PAUL MEW ASSOCIATES
TRAFFIC CONSULTANTS

PROPOSED WELLCOME TRUST DEVELOPMENT
AT 63-81 PELHAM STREET, LONDON SW7 2NJ

INDEPENDENT TRANSPORT, DELIVERY & SERVICING AUDIT

March 2021

- 2.22 An extract of the swept path analysis presented as part of the submission is shown below and illustrates that there would be insufficient space for 2 buses to pass. Loading Bay / Carriageway Width Issue

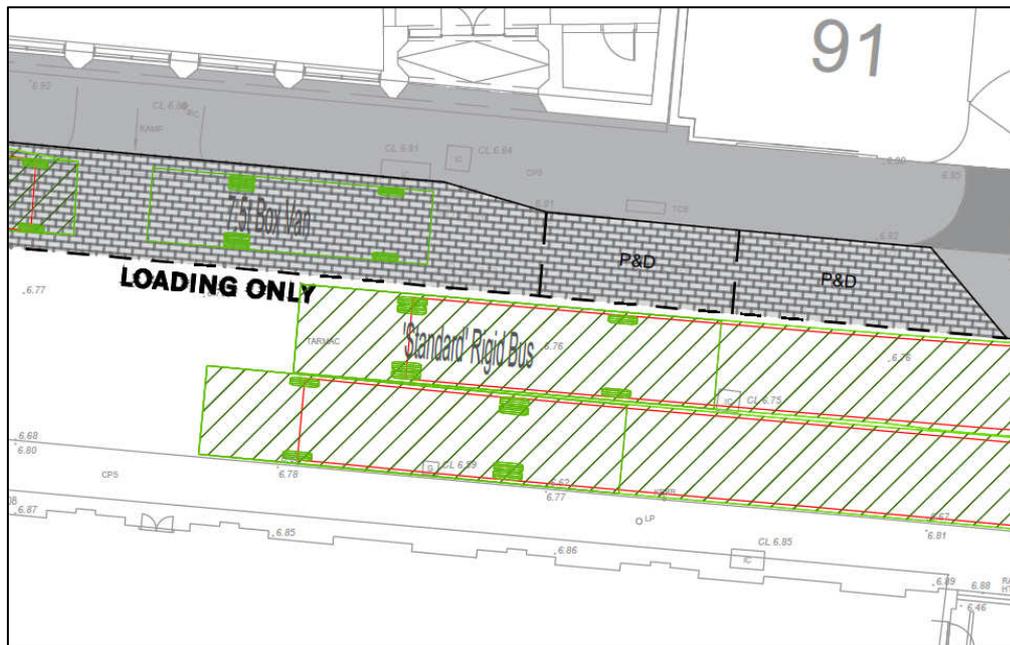
- 2.19 Figure 7.4 of the Transport Assessment shows swept path analysis for a goods vehicle entering the proposed loading bay and 2 vehicles passing adjacent to the loading bay. It also suggests that there would be insufficient width for 2 buses to pass one another.

- 2.20 This problem was identified in the Stage I Road Safety Audit (Appendix E) which set out that:

The northern footway is being widened to accommodate shared use parking / loading bays. However, the width of the carriageway at this point is being narrowed to 5.5m and there is a two-way local bus service with a frequency of every 12 minutes. Swept paths of buses were provided for assessment, where the margin for error is minimal, which could lead to vehicle incursion into shared use parking / loading bays, the opposing running lane or collisions with pedestrians on the southern footway.

Large vehicle incursion into shared use parking / loading bays could lead to collisions with parked vehicles or vehicle to pedestrian collisions, whilst incursion into the opposing running lane could lead to side swipe collisions.

It is recommended that the northern footway width should be reduced, allowing the carriageway width to be widened thereby increasing the margin of error for passing buses and other large vehicles.

- 2.21 The applicant has not provided a 'designer's response' to the problems raised in the Safety Audit and no amendments to the layout appear to have been made.
